Amendments to the Drawings:

Remarks

FIG. 1

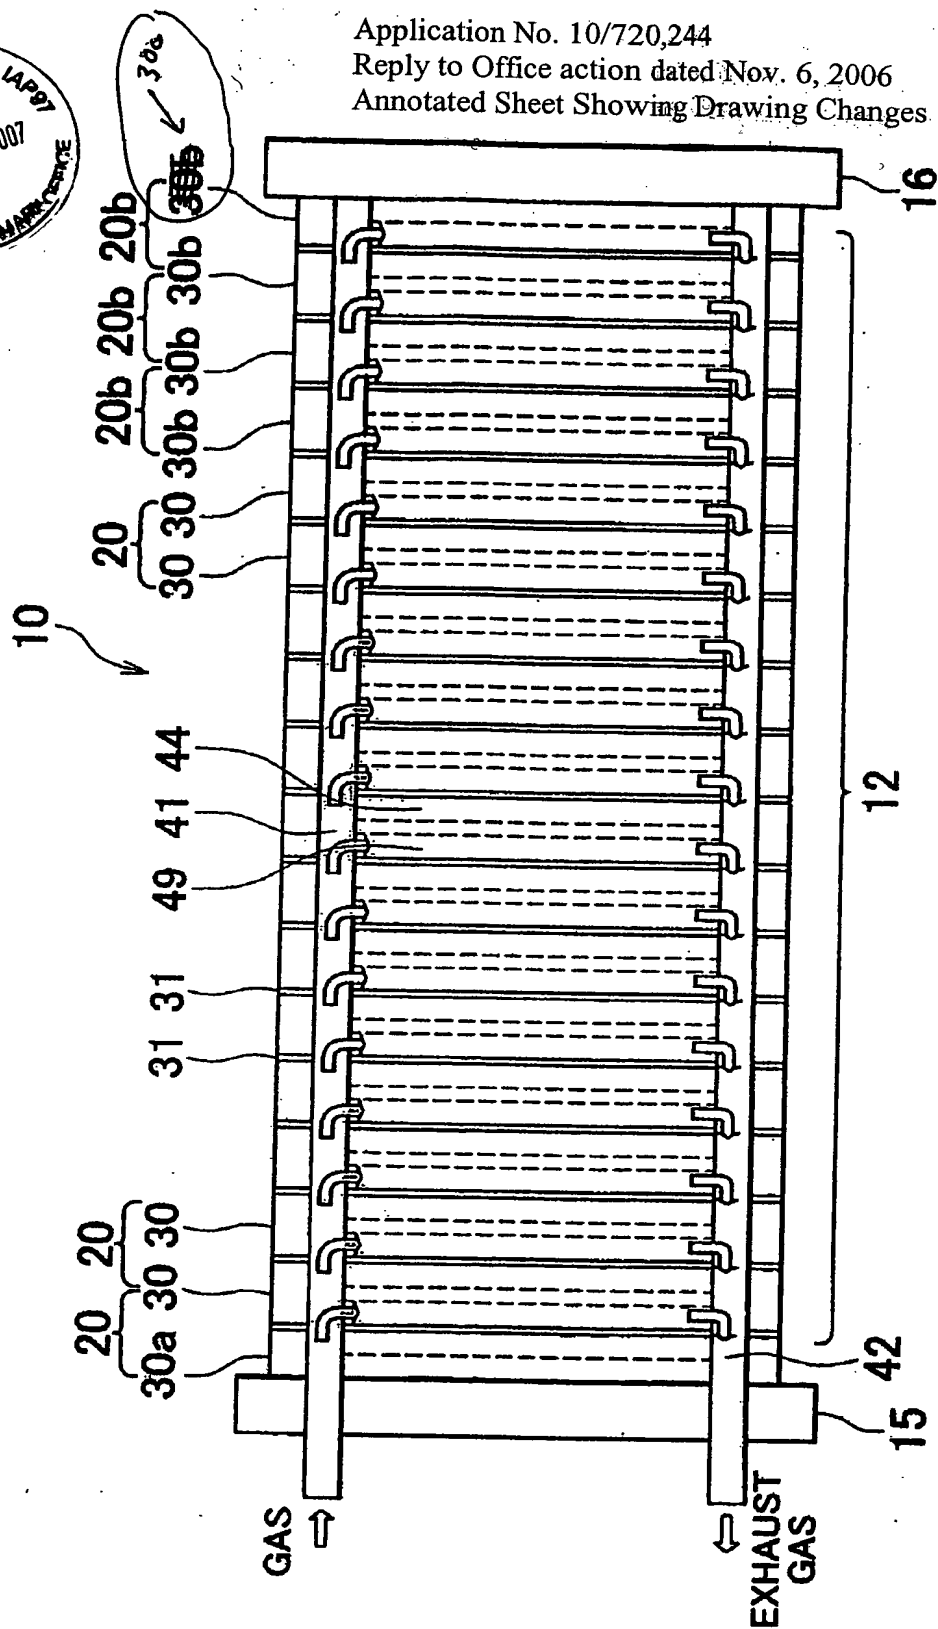
The attached sheets of drawings includes changes to FIGS. 1, 2 and 3a-b. These sheets, which include FIGS. 1, 2 and 3a-b, replace the original sheets including FIGS. 1, 2 and 3a-b. In these Figures, improperly labeled elements are changed and previously omitted elements 20b, 30b, and 30c are added.

In amended FIGS. 1, 2 and 3a-b, reference numerals are changed to correct minor editorial errors.
